JOB NO. 048 DRG. NO. 6

SHOP DRAWING REVIEW

PROJECT NO. IM IR 089 1(13) STATE PROJECT NO.
MATERIAL: A709-36 ELECTRODES: HOLES: 15/16 SHOP BOLTS:
SURFACE PREP. & PAINT: SSPC-SP10, SHERWIN WILLIAMS
PRIMER: ZINC CLAD IV B69W8/B69V5
SHOP COAT: HEAVY DUTY EPOXY B67W301/B60V3
FINISH: HI SOLIDS POLYURETHANE B65W301/B60V30
DESCRIPTION: GUSSET PLATES
JOB: I-89 NB & SB over WHITE RIVER, VT 14 & NECR HARTFORD, VT

g6c: 2 REQ'D
1 @ REPAIR ID # S4
1 @ REPAIR ID # S21

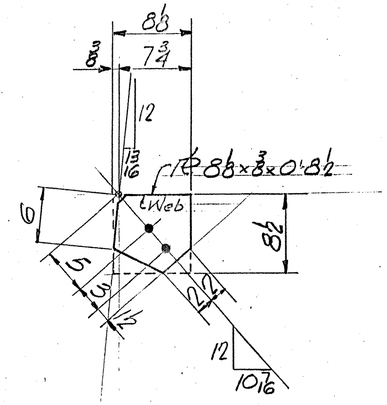
Confirm should be 6 1/8 according to details
TRS

g9: 1 REQ'D
@ REPAIR ID # N13

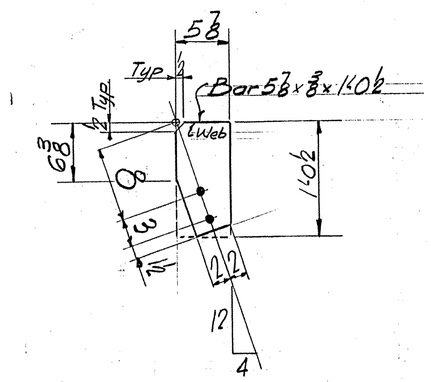
Where are field welding procedures?

VERIFY. SWITCHED?
YES
